**WHEELING PLAN COMMISSION
THURSDAY, JULY 12, 2018 6:30 P.M.**

**AGENDA FOR A REGULAR MEETING OF THE PLAN COMMISSION
Board Room - 2 Community Boulevard, Wheeling, Illinois
REVISED JULY 10, 2018**

REQUEST FOR PLAN COMMISSION ACTION
STAFF PROJECT REVIEW

RE: **Docket No. 2018-13A,B&C**
JV Global Services
Southwest corner of Wolf Road and Kerry Lane: (Lots 1 through 8 of the Wolf Road Estates, the adjacent vacant lots north of Debra Lane and east of Wolf Road, and the existing Carol Avenue right-of-way)
(2018-13A) Text Amendment to Add 'Transportation Center' as a Special Use in the I-3 General Industrial District
(2018-13B) Rezoning from I-1 Light Industrial District and R-1A Single-Family Residential to I-3
(2018-13C) Special Use-Site Plan Approval of a Transportation Center

- Property Line
- Fence Line
- Telephone Pole
- Parking Lot
- Grass

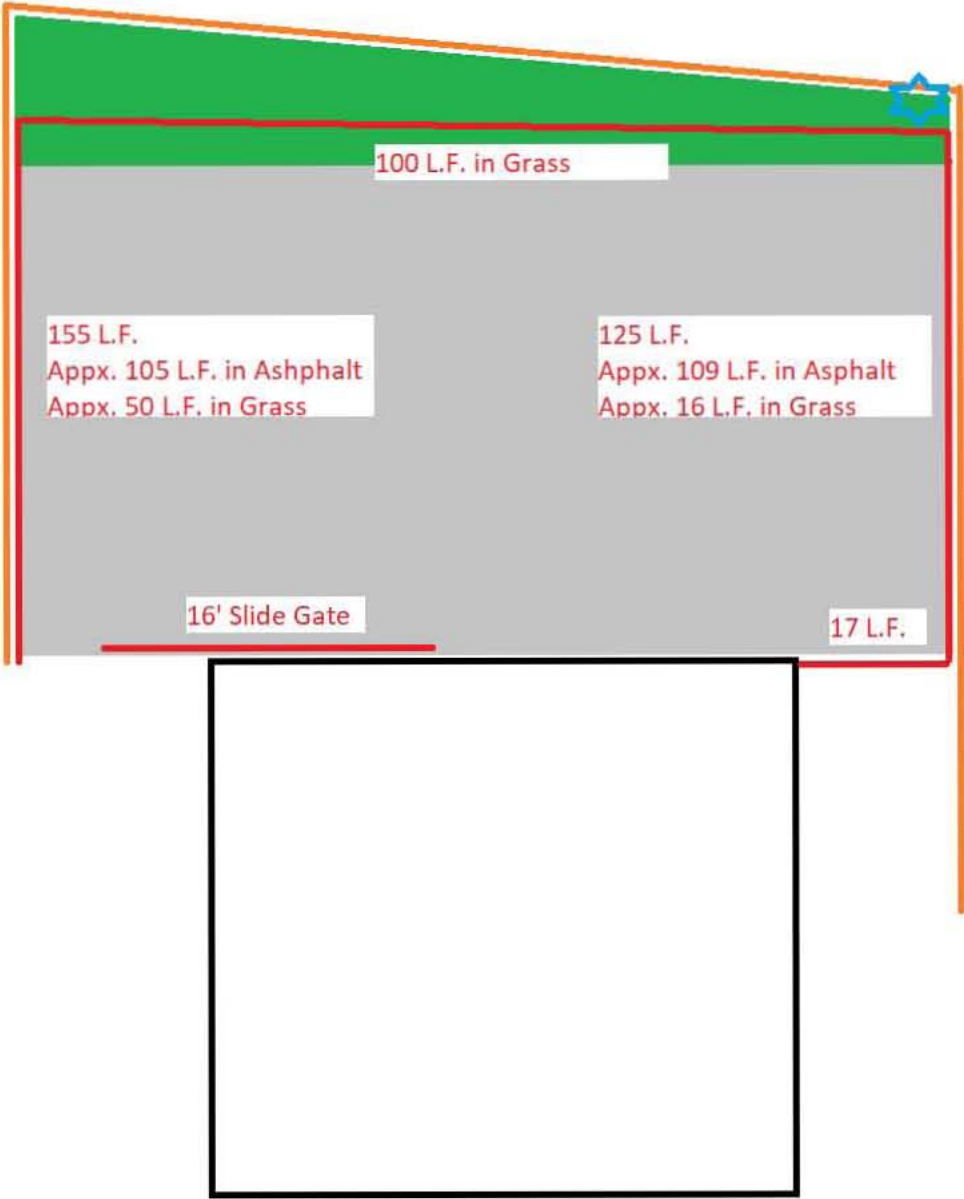
Fencing: An 8-foot tall galvanized chain link fence with barbed wire is proposed for the rear yard. The site plan notes the proposed placement. Three exhibits have been provided to demonstrate the style and materials of the fencing and gates. Title 22 of the Municipal Code, Floodplain Regulations, prohibits fencing in the FEMA Floodway and restricts fencing in the FEMA Flood Zone. While the exact boundaries of the FEMA Flood Zone and Floodplain are unknown at this time, the Village Engineer believes that the petitioner will be able to construct a fence surrounding the rear parking lot. The Plan Commission should make a determination if the 8-foot height is appropriate and if the barbed wire is acceptable.

Impact on Adjacent Uses: The Plan Commission should make a determination as to whether the 8-foot chain link fence with barbed wire is appropriate for the location.

SITE PLAN

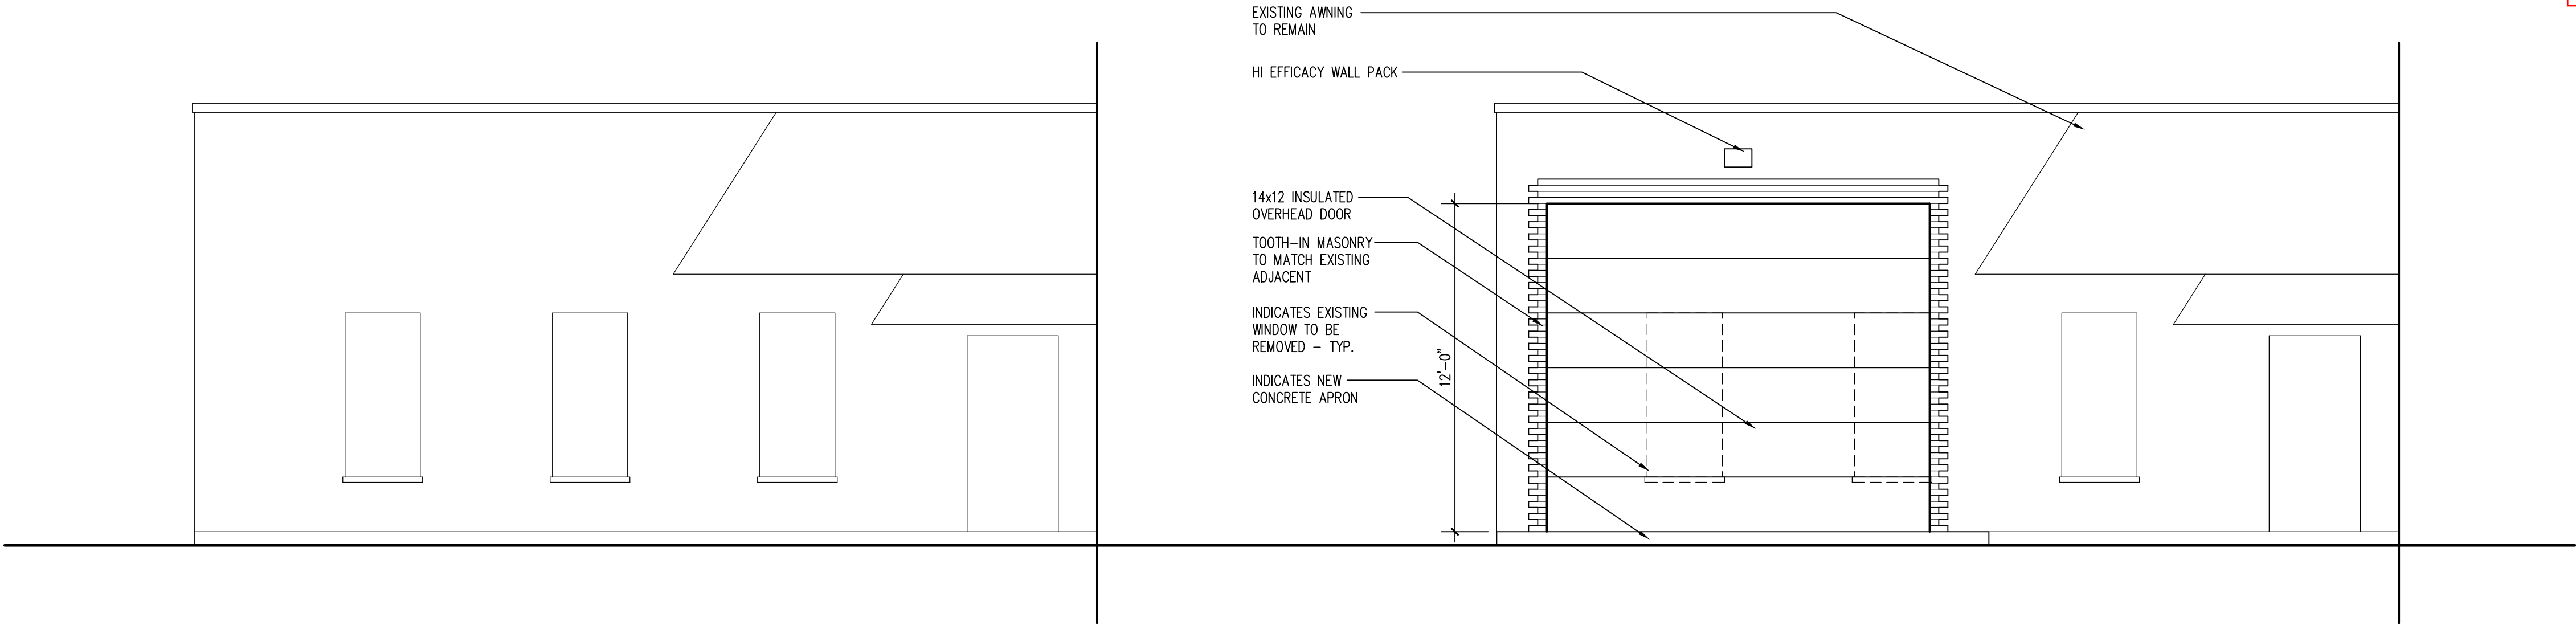
Site plan: No outdoor storage is proposed for the rear yard. See the discussion on fencing below. Two parking spaces in the front parking lot will need to be removed to accommodate a new overhead garage door on the front façade.

Building Appearance: An overhead garage door is planned for the front (east) façade of the building. The door is 14 feet wide and 12 feet high. Sheet A-1 provides details. The location of the new door will displace two parking stalls.

Date	6/21/18
Scale	AS NOTED
Drawn	RJB
Job	1807
Sheet	CE-1
Of	1

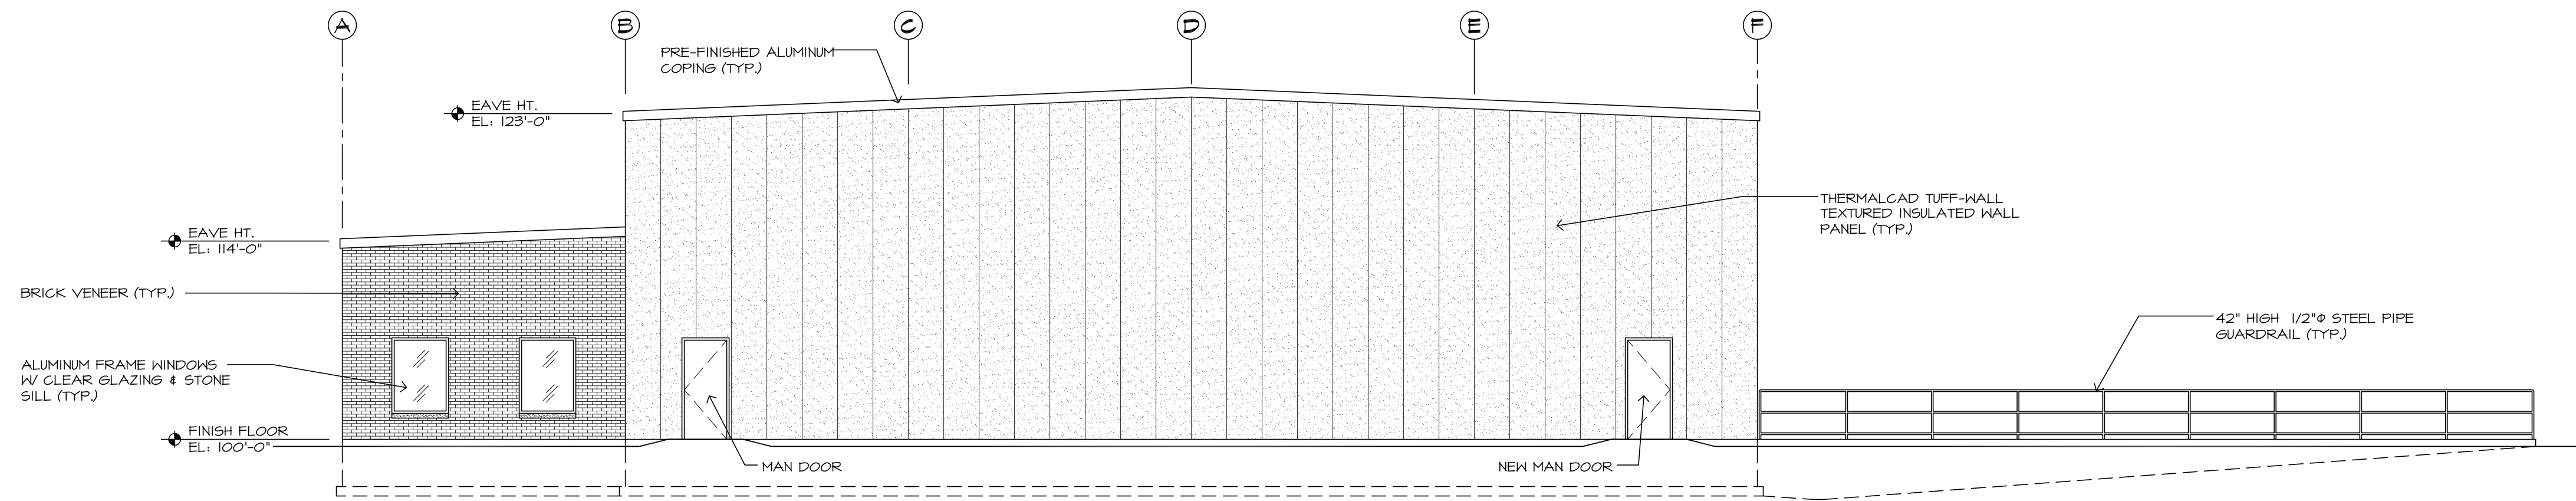
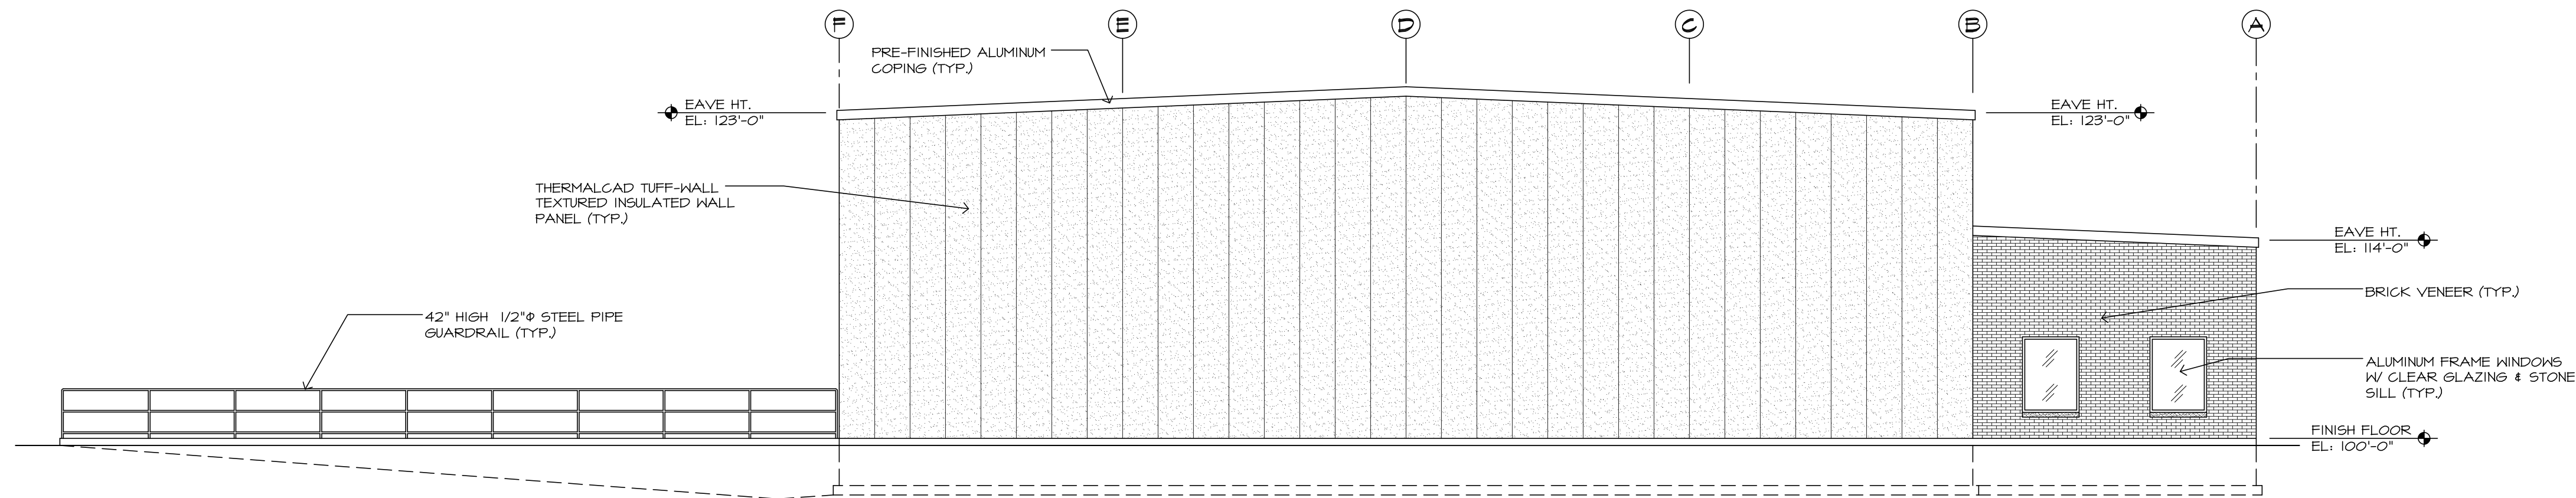
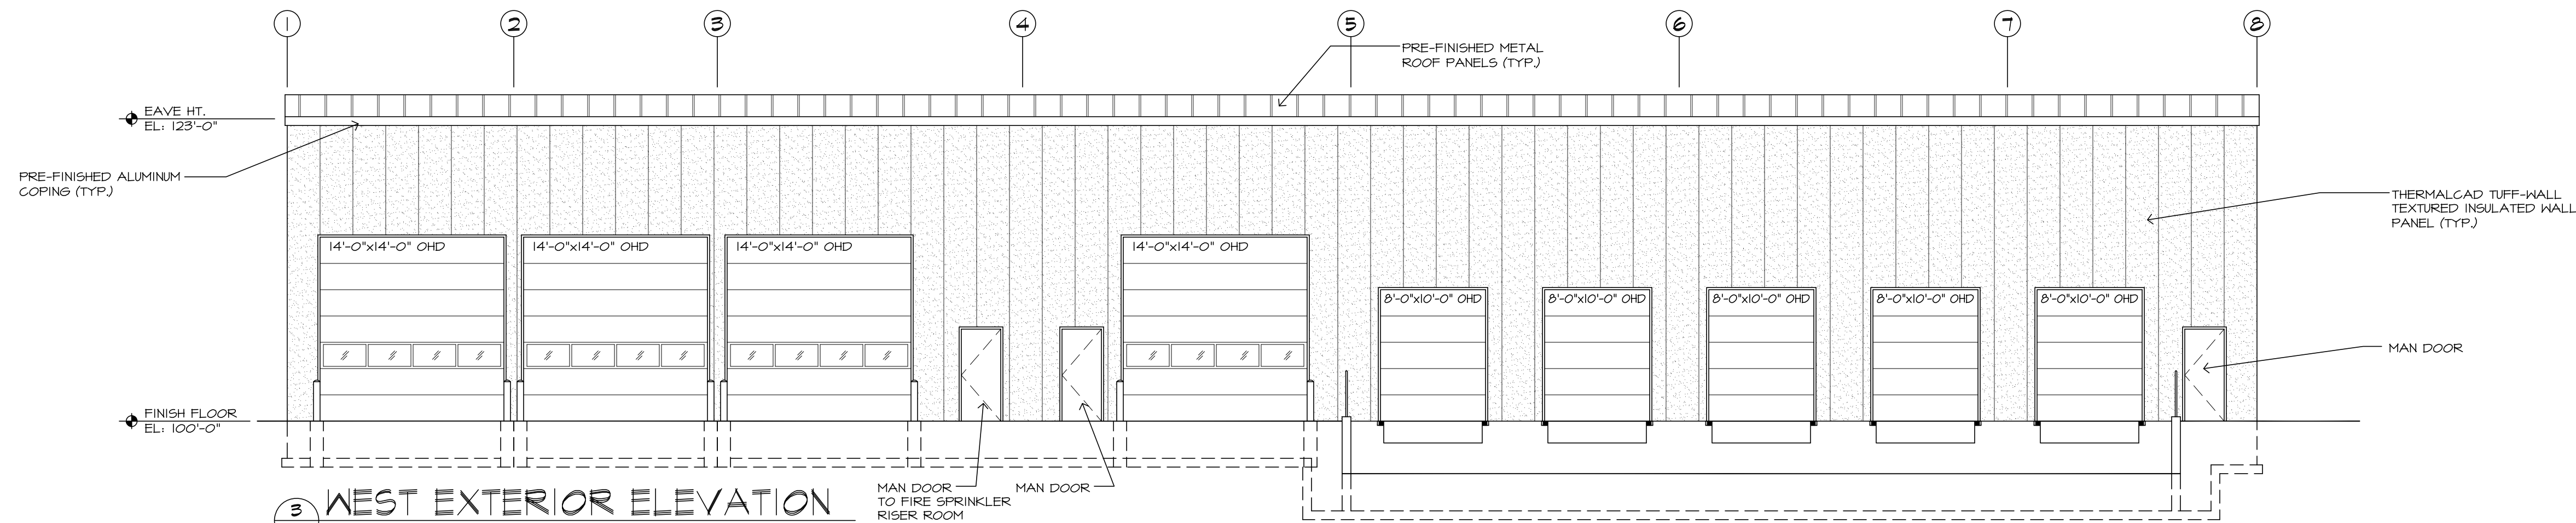
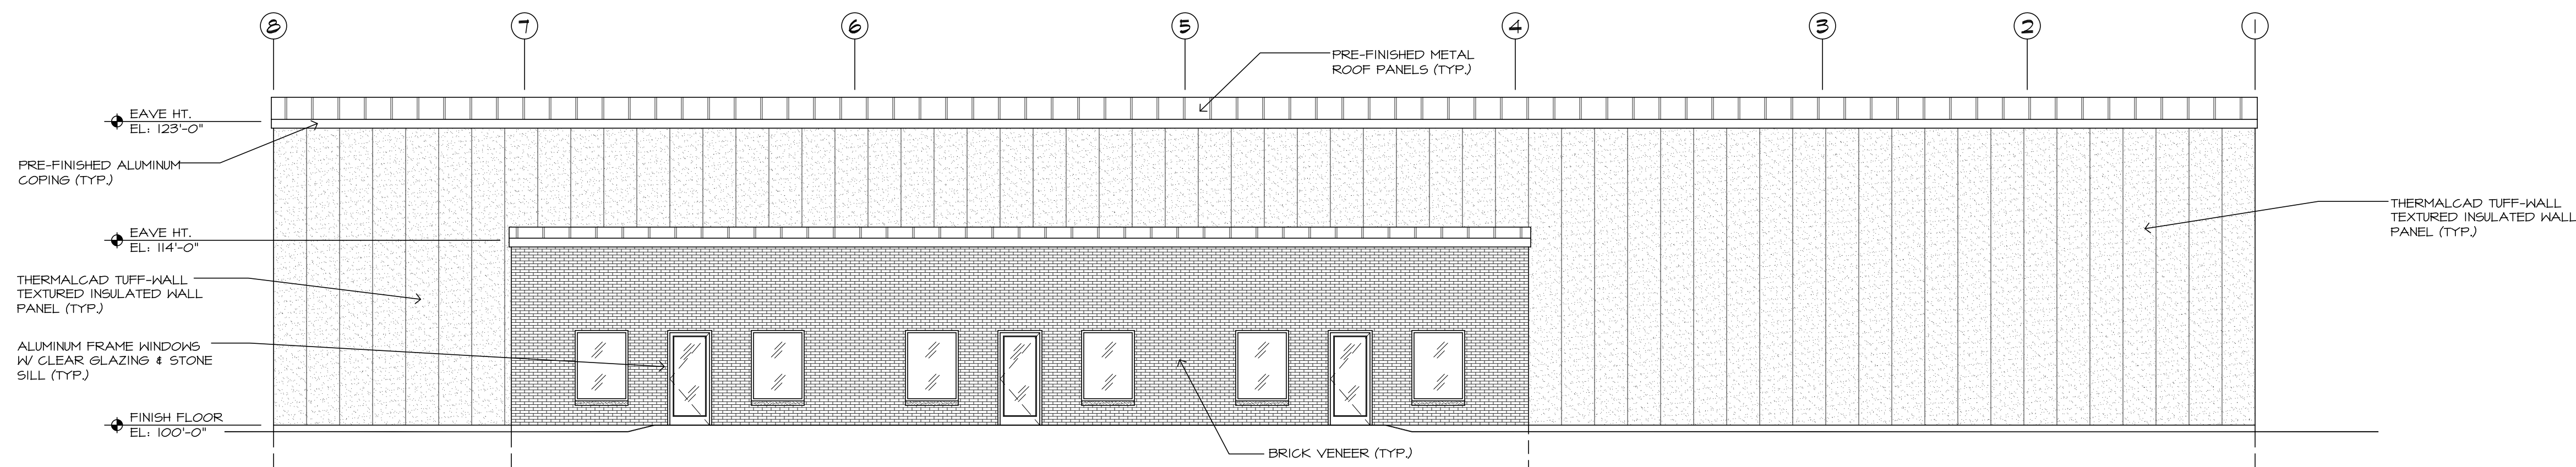
Elevation Plan Review: A one-story building, with a very low-pitched roof, is proposed. The warehouse portion of the building will be 23-feet high. The east elevation includes 14-foot high offices. The loading dock is found on the west side of the building and includes nine overhead garage doors.

Exterior Building Materials: The warehouse portion of the building will be comprised of a Thermalclad Tuff-Wall textured insulated wall panel system. Product details for the wall system has been provided. It does not appear that this material is listed as an acceptable wall material in the Design Guidelines. The Plan Commission may wish to discuss the use of this material. The office portion of the building is clad in a brick veneer. Windows are located on the east, north, and south

MAY 23, 2018 JUNE 20, 2018		ROONEY CONSULTANTS, INC. LAKEMOORE, IL (815) 341-0910		4
SECTION A-A				
J.V. GLOBAL SERVICES WOLF ROAD AT KERRY LANE WHEELING, ILLINOIS

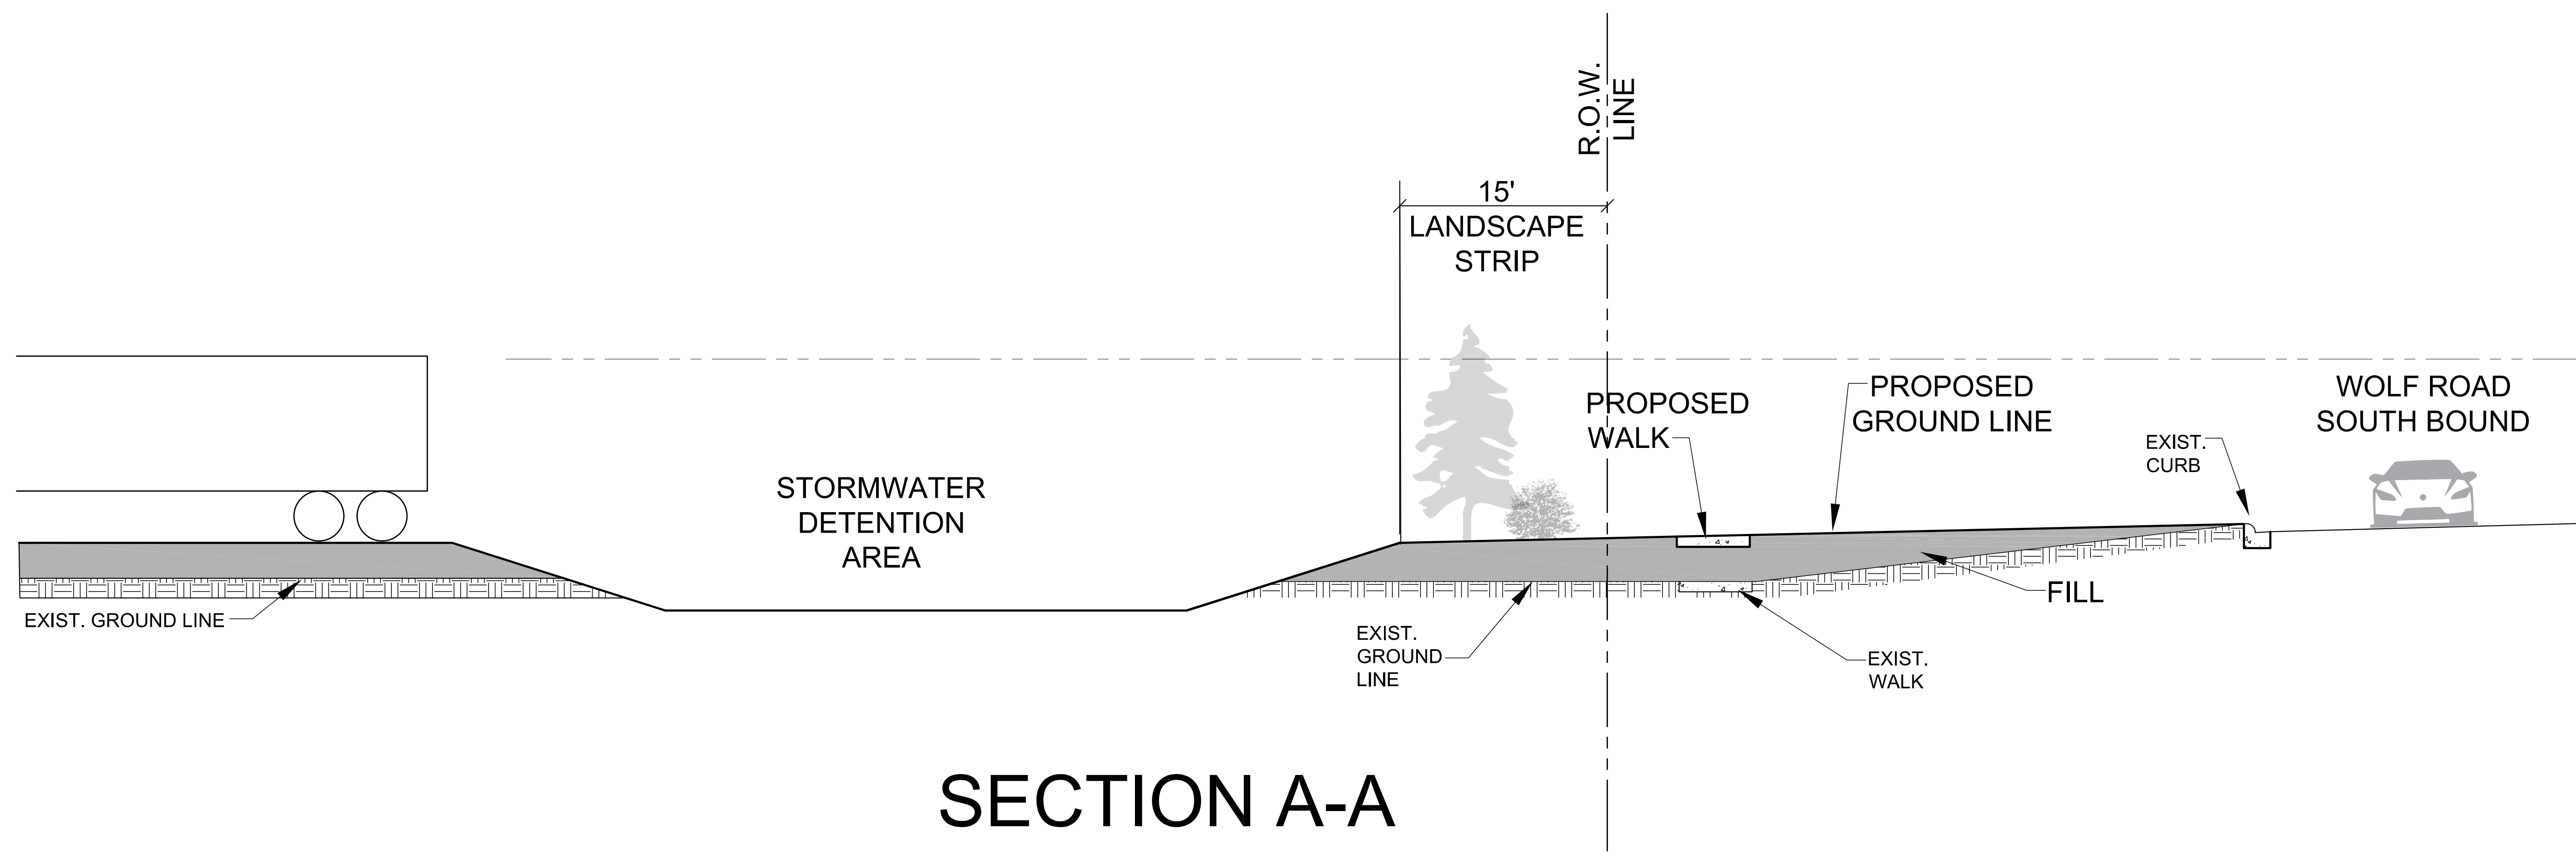
Landscaping Plan Review: Heavy landscape screening is proposed for the east and south property lines. Screening will be accomplished by a mix of deciduous (Sour Gum, Swamp White Oak) and coniferous trees (Eastern Red Cedar, Colorado Spruce). Ornamental trees, such as Speckled Alder, Autumn Brilliance Serviceberry and River birch, are also proposed. A prairie mix of ground cover is proposed for the detention basin. No flowering perennials are proposed in the landscape plan. Foundation plantings are not proposed for the building. The Plan Commission may wish to discuss other opportunities to add colors and flowers to the site.
